drawing title:
LEGENDS, SCHEDULES, EQUIPMENT LISTS, & NOTES

LMC SCIENCE 313-023-112.01-0-00.00
drawing no:
P0.1
drawing of ?

SCIENCE BUILDING
LOS MEDANOS COLLEGE
Pittsburg, CA
Contra Costa Community College District

PLUMBING - MECHANICAL ROOM FLOOR PLAN

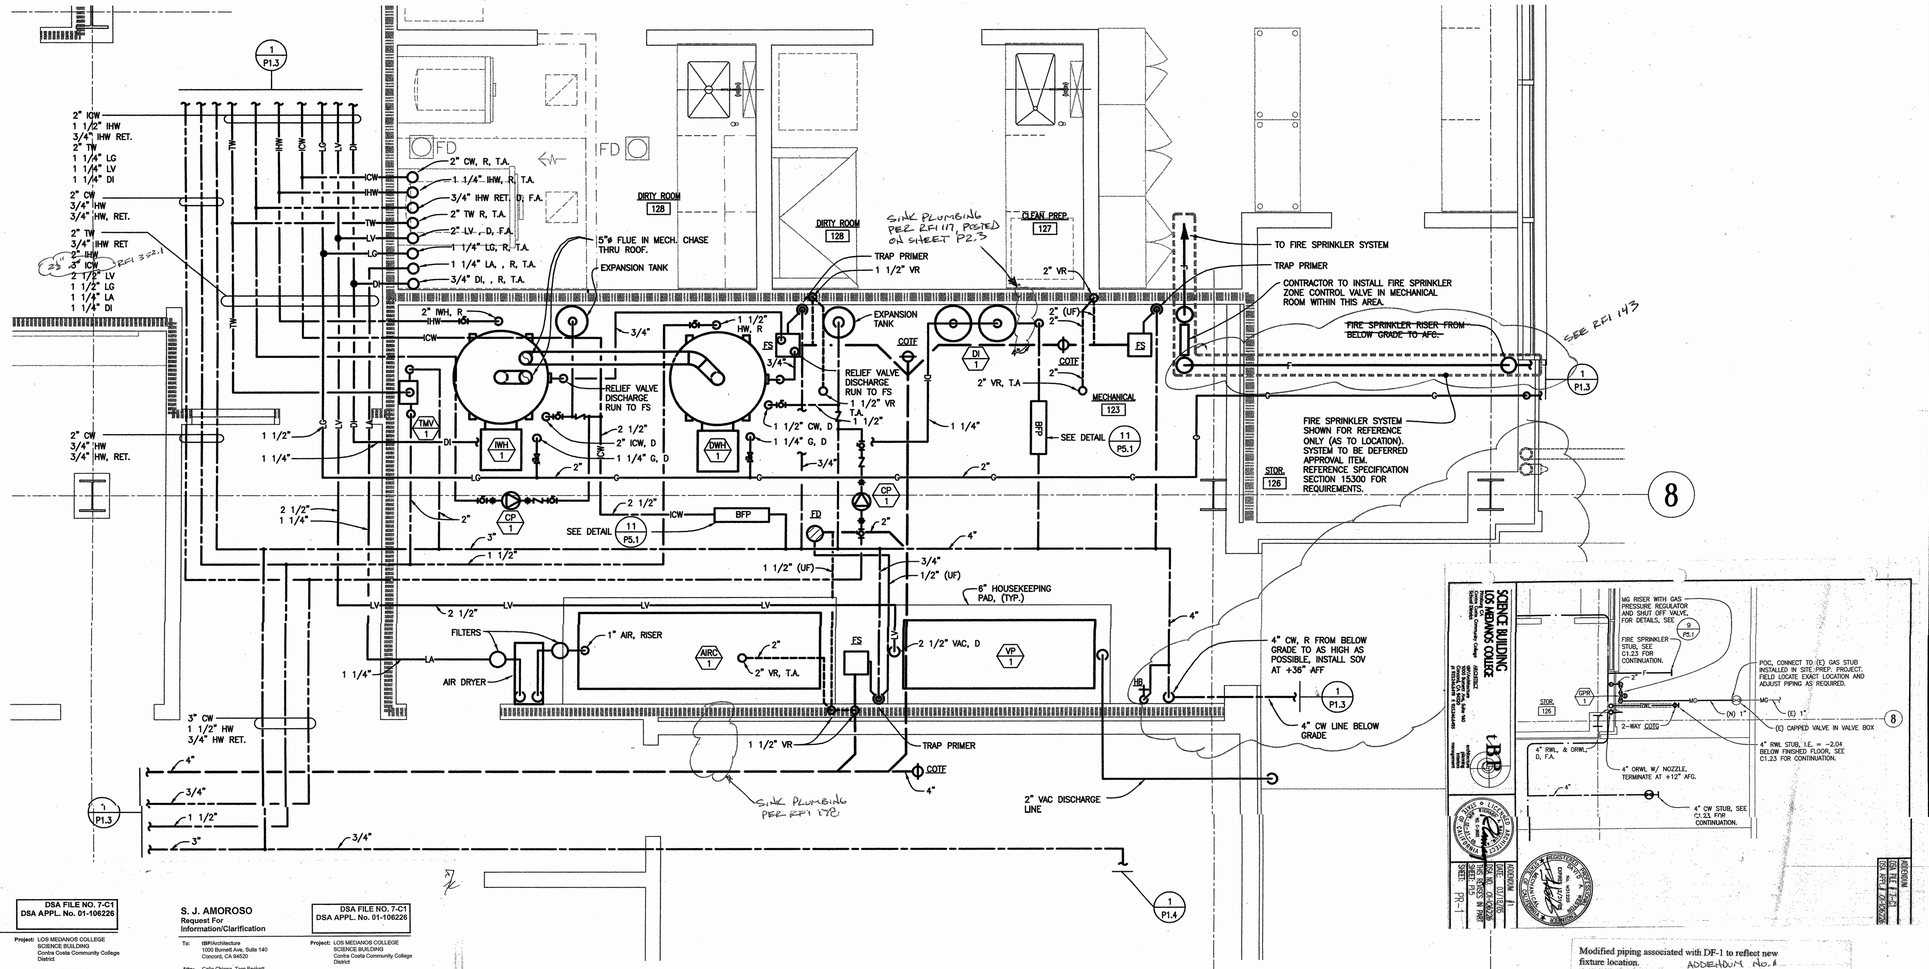
On sheet P2.3, a sink S-1 is shown at F.5 and 8.2 lines. The 2" sanitary sewer shown is not depicted below on sheets P1.3 or P1.5. Please advise where this line is to terminate.

On P1.5, at F.5 and 8.1, a back flow preventer is shown. This ICW line is shown to be 2.1/2". This supplies the IWH-1 and the ICW to the Building. The ICW that feeds the Building is shown to be 3". This is depicted on F-line of this page. Is the pipe sizing of the ICW described correct? Please advise.

2" sanitary sewer line to drop at location indicated, drop within south wall of mechanical room, then connect to 4" sanitary sewer just south of mechanical room (see sheet P1.5).

See attached photocopy partial plan of sheet P1.5 with ICW pipe sizes circled so as to be as easy to read as possible. Note that Dowdle's original question is, in fact, correct. The ICW pipe size goes from 4" to 2 1/2" to 3". That is why the question was asked in the original RFI 352. Note that SJA/Dowdle were simply trying to be proactive and address a very unusual situation in the plans INSTEAD of simply, blindly following the drawings and perhaps constructing things that are per plan, but not what the end user actually needs.

1 / P2.1

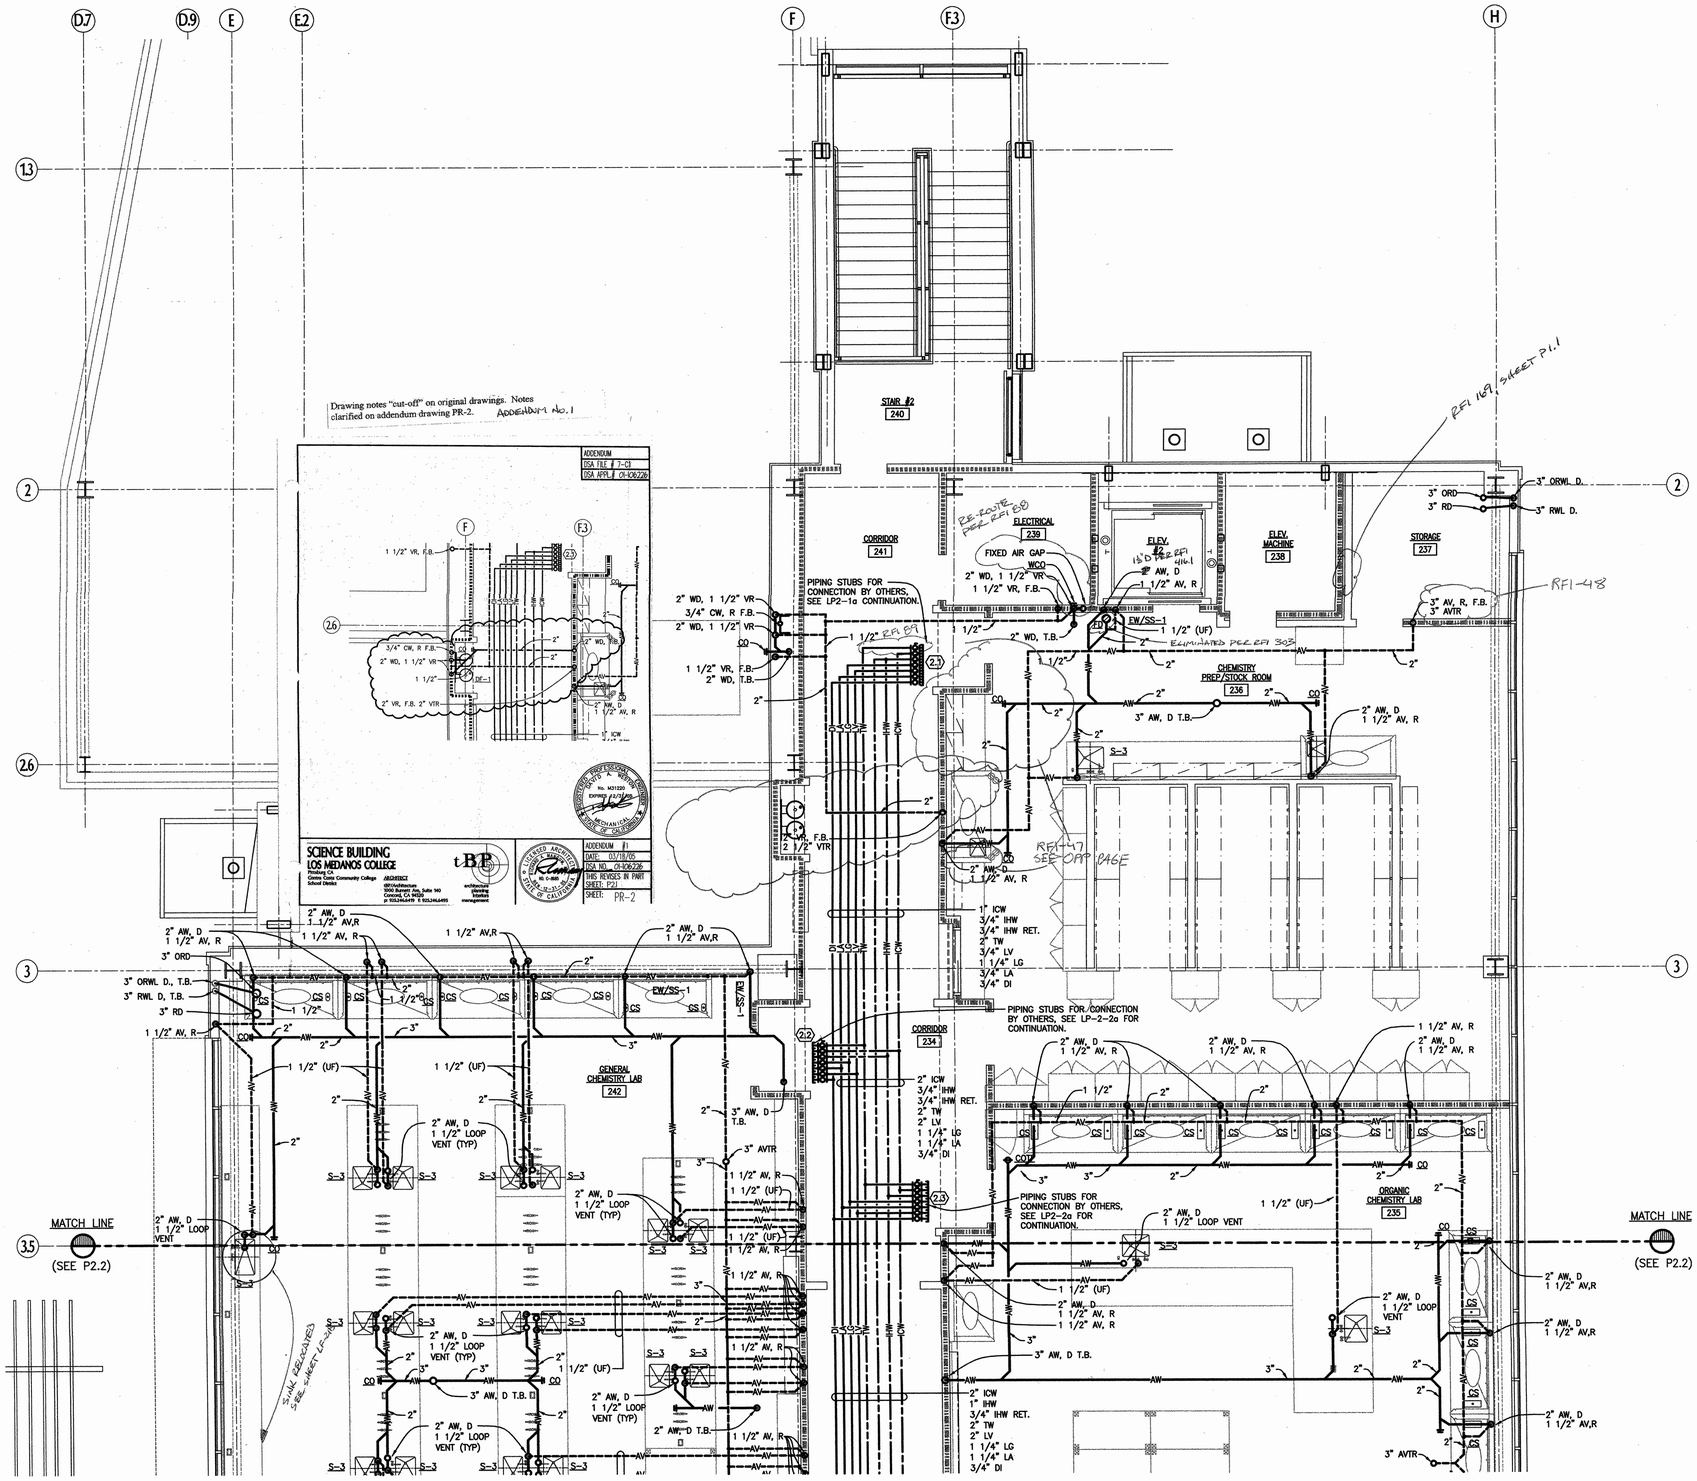
INFORMATION REQUESTED: Date: 1/10/06
Please note the attached Dowdle and Son's RFI No. 18 regarding the fixed air gap on P2.1 and wall clean out that are shown in a 2 hour wall.

Drawing notes "cut-off" on original drawings. Notes clarified on addendum drawing PR-2. ADDENDUM No. 1

1 / P2.2

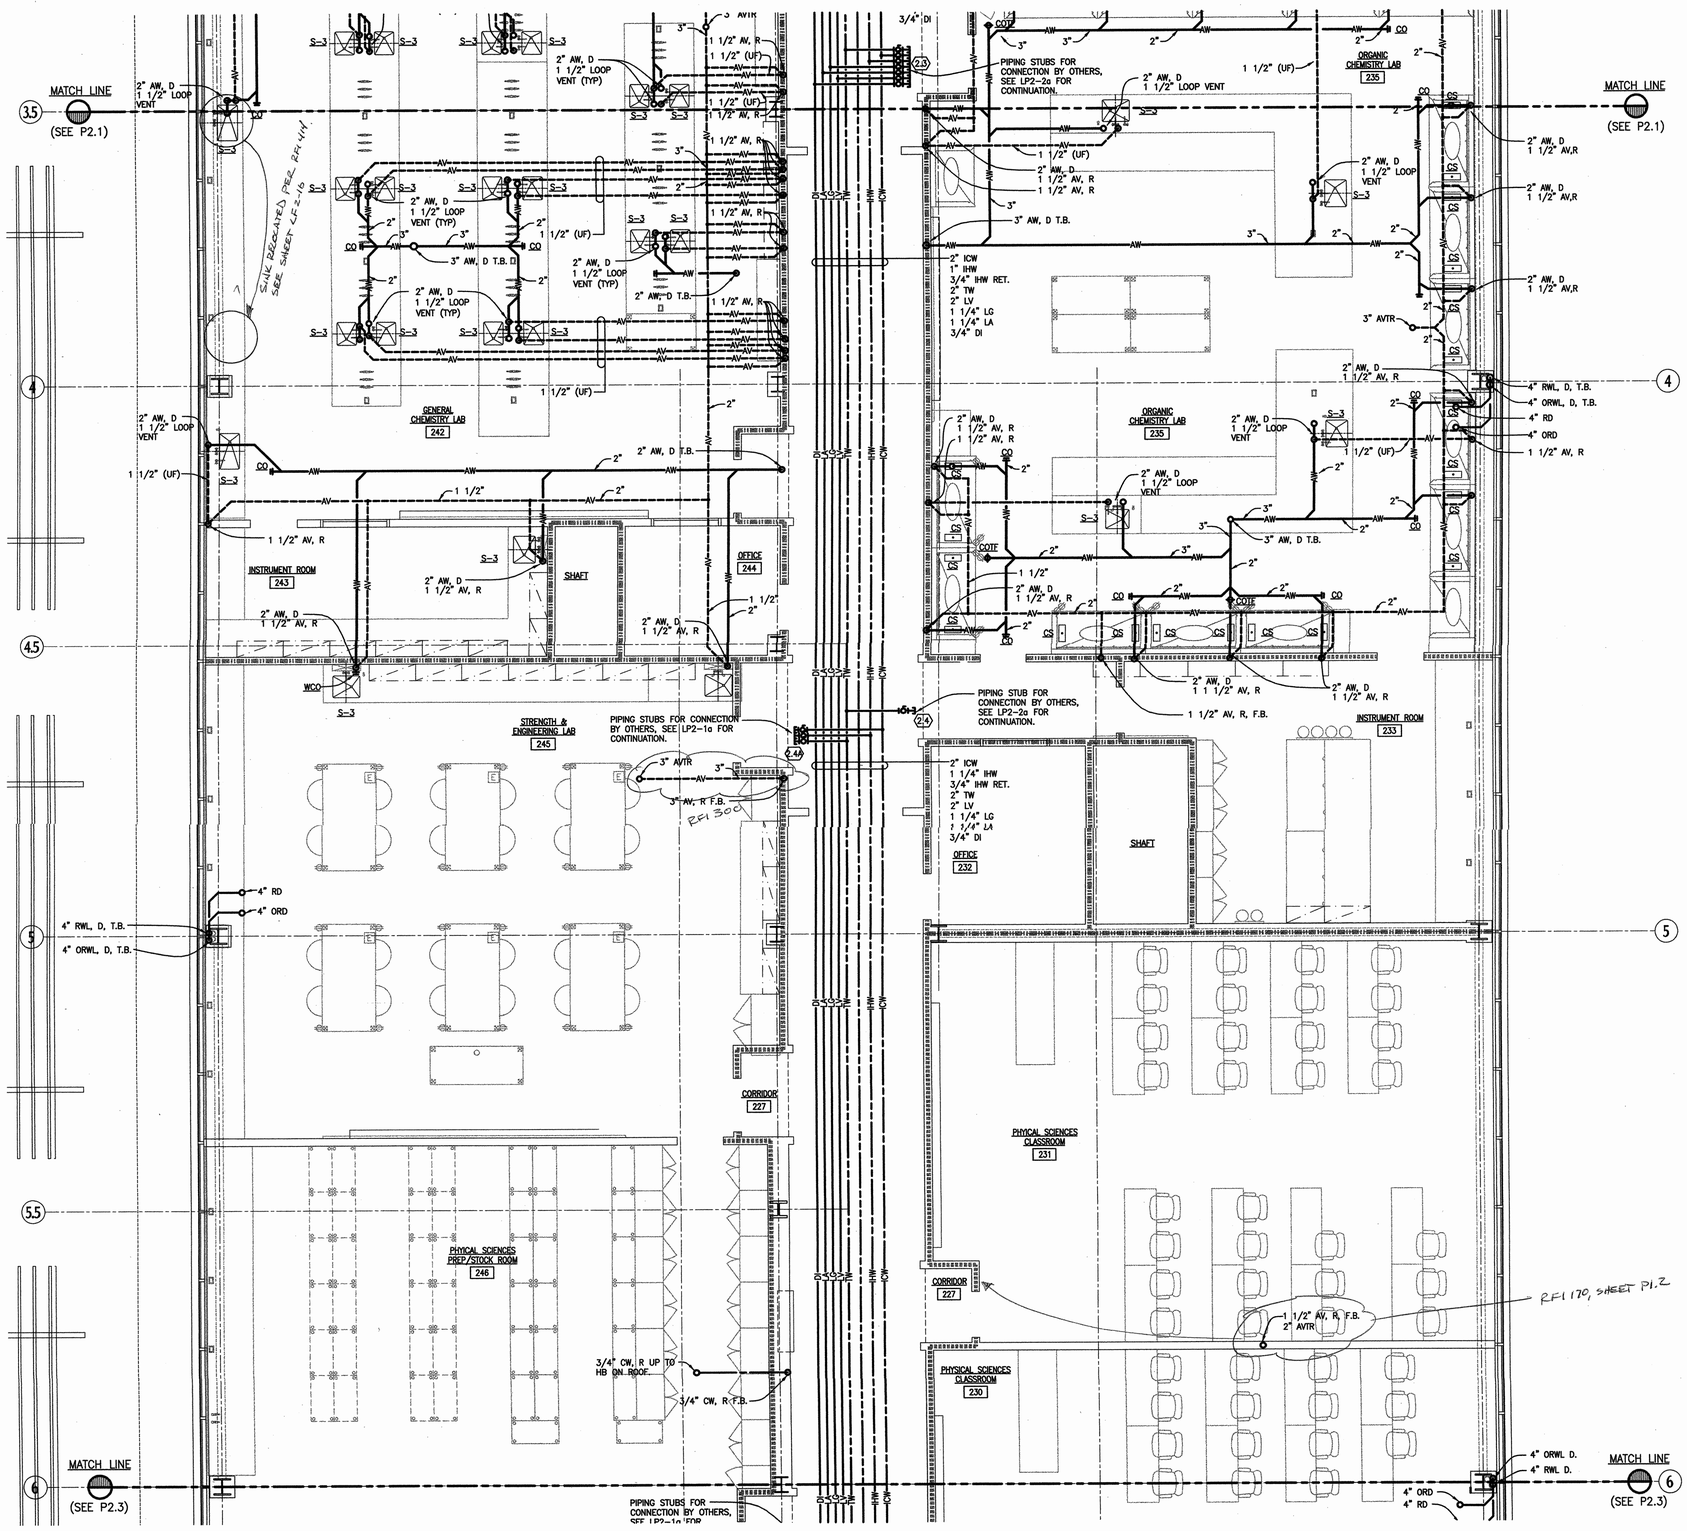
Note that on sheet P2-2, near the northern entrance to room 245, a 3" AVR is shown in the corridor wall. However, this AVR would be in conflict with the T-line beam above this corridor wall. Therefore, we propose re-locating the AVR to rise up in the east-west alcove wall near door 249. Once into the 1st floor ceiling space, the AVR can be routed to it's "correct" roof penetration location. In order to accomplish this, the alcove wall would need to be increased form 4" studs to 6" studs. We have discussed this with our lab casework subcontractor and we believe that this wall can "grow" into the lab by 2" and that the casework can "absorb" these two inches in the KO panel located at the F/5 column. Please confirm the stud size increase.

PLUMBING - 2ND FLOOR- PARTIAL PLAN

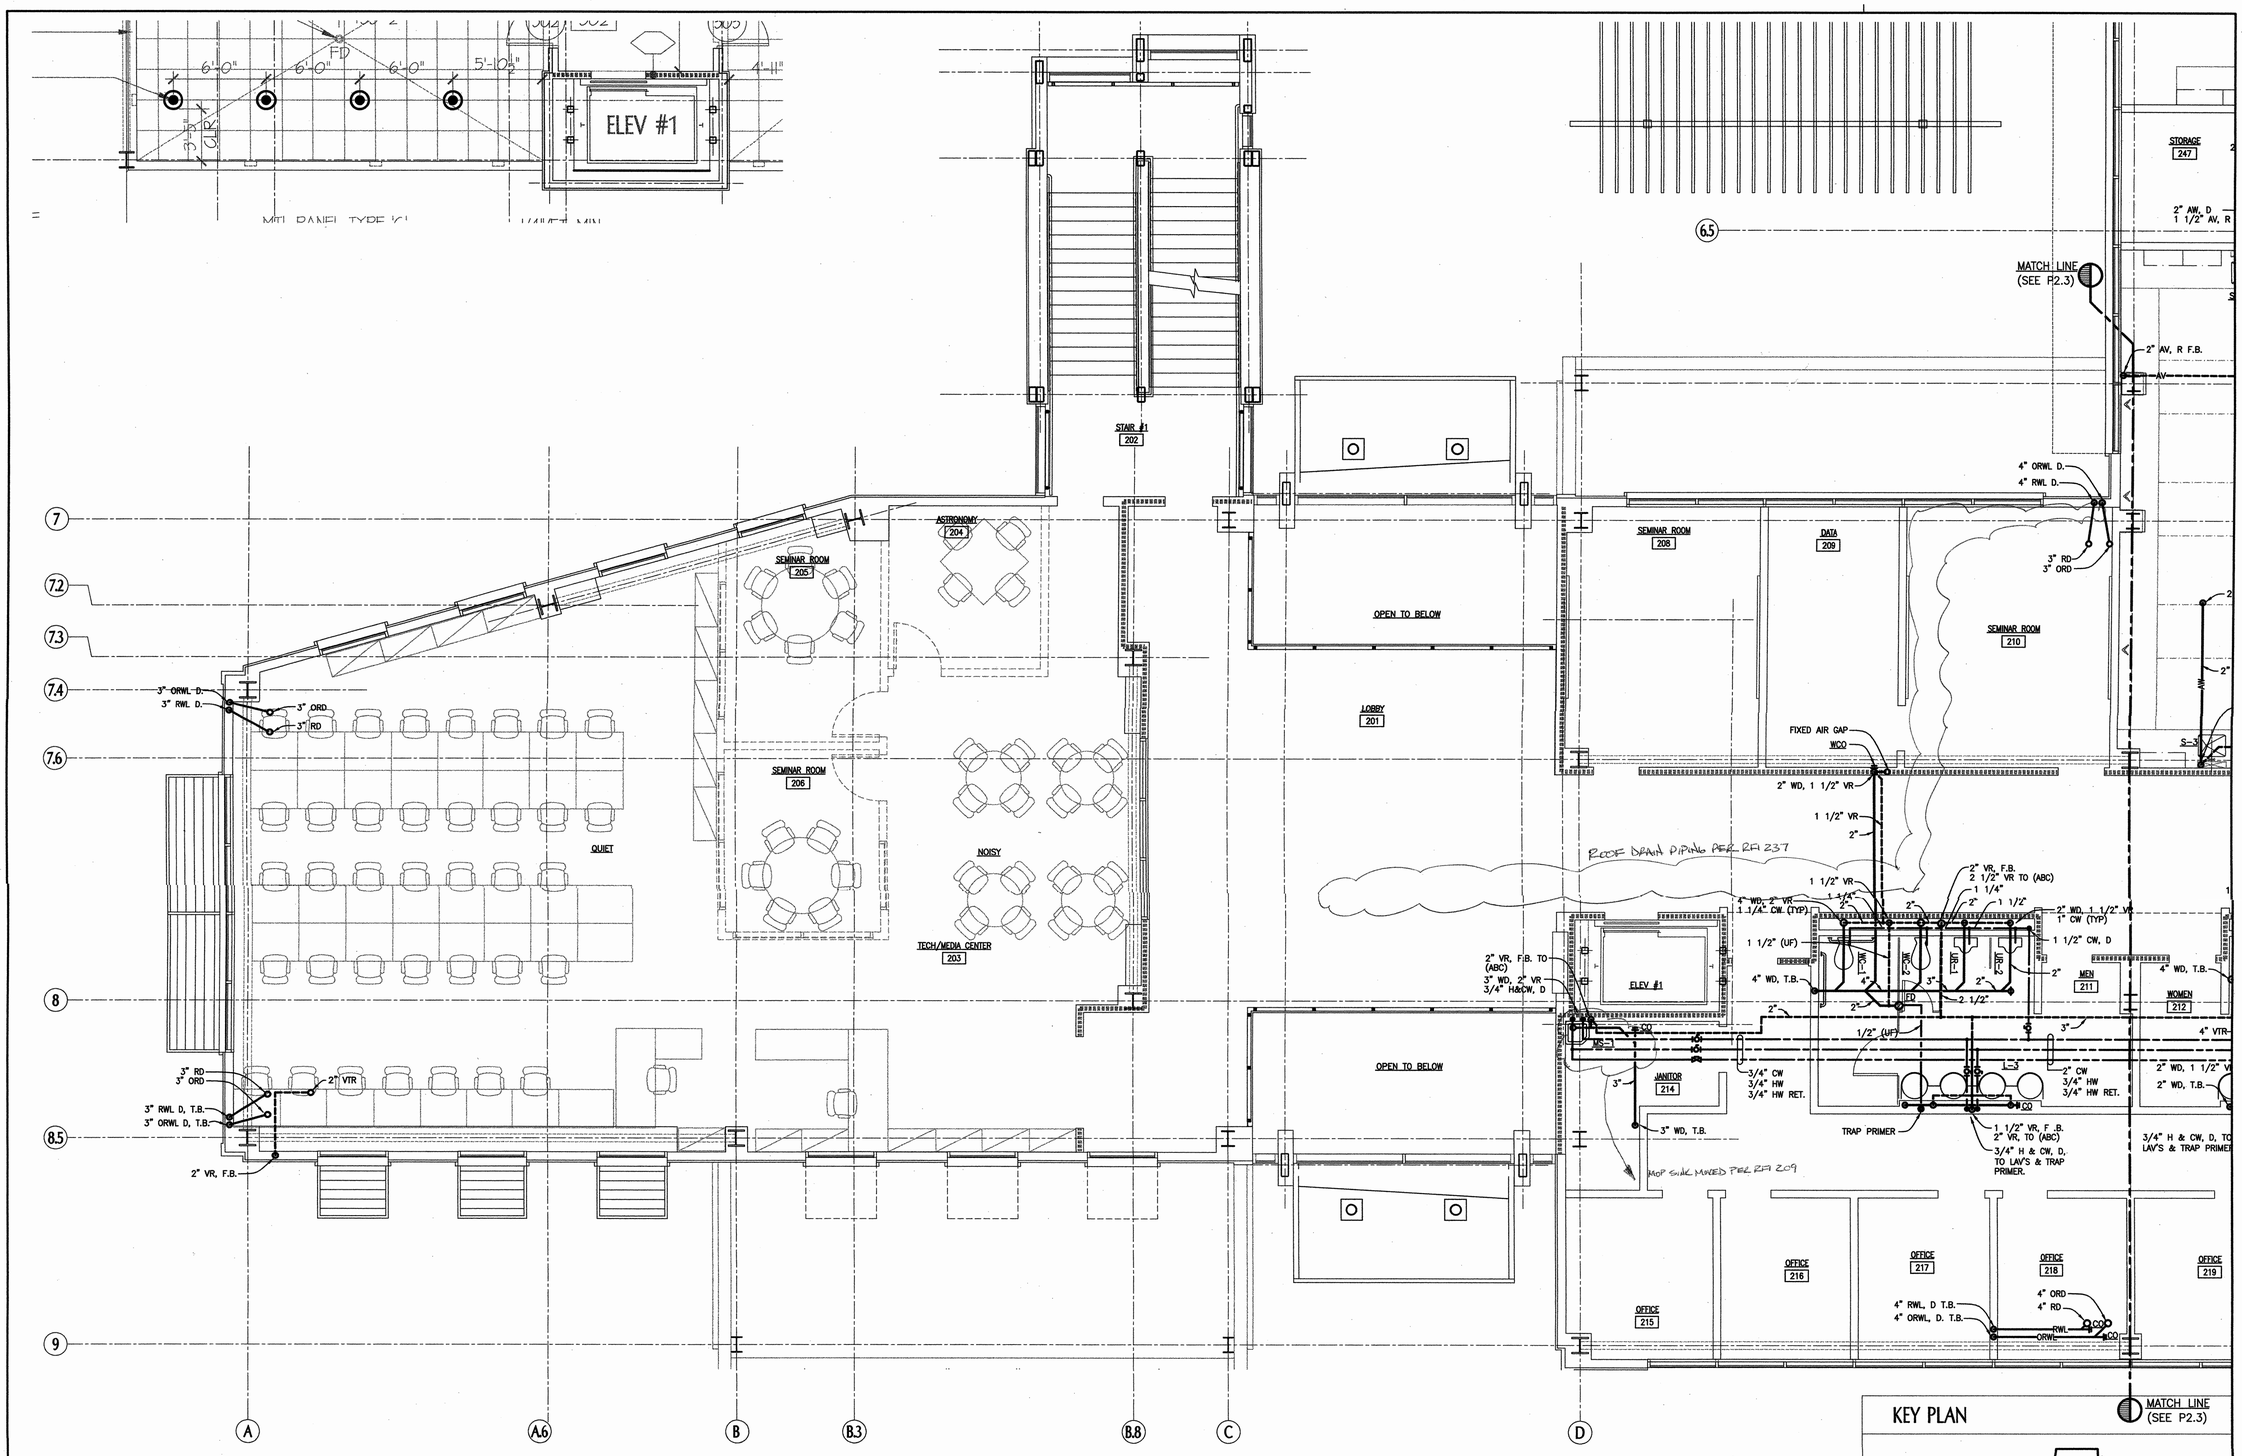
Please note the attached Dowdle and Sons RFI regarding the MS-1 shown on P2.4 at D and 8 line w/duct the drain for this fixture lands directly on the flange of the W33 on D line. Please advise.

6 / P5.1

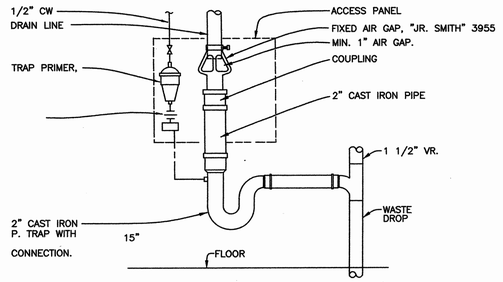
Please note the attached Dowdle and Sons RFI #64 regarding the Fixed Air Gap shown on 6/P5.1. No Cold Water lines are shown in the vicinity of this fixed air gap fitting. Will a cold water line be necessary to supply the trap primer valves or will the constant flow of condensate from the air conditioning units be sufficient. Please advise.

Request: **Date Required: 6/23/2006**
On 6/P5.1 a Fixed Air Gap is shown. The detail depicts a 1/2" CW Pipe to Supply a trap primer valve. At 2.3 and F.3 and 7.8 and E.2 on P1.1 and P1.3 no cold water piping is shown in the vicinity of the fixed air gap fittings. Will a cold water line need to be installed to supply the trap primer valves or will the constant flow of condensate from the air conditioning units be sufficient to maintain a proper trap seal? Please advise.

7 / P5.1

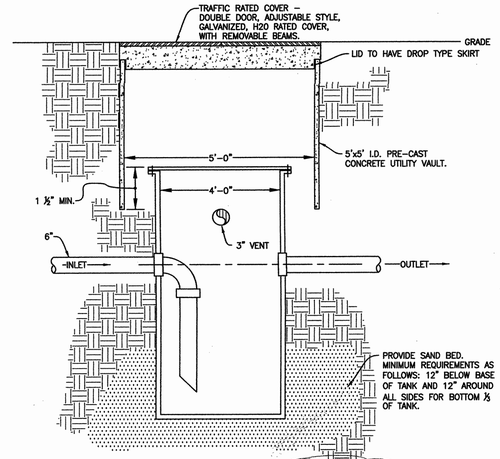
Based upon existing site conditions and review with geotechnical engineer, the neutralizing sump detail per detail 7/P5.1 has been revised as SKA-21.1.
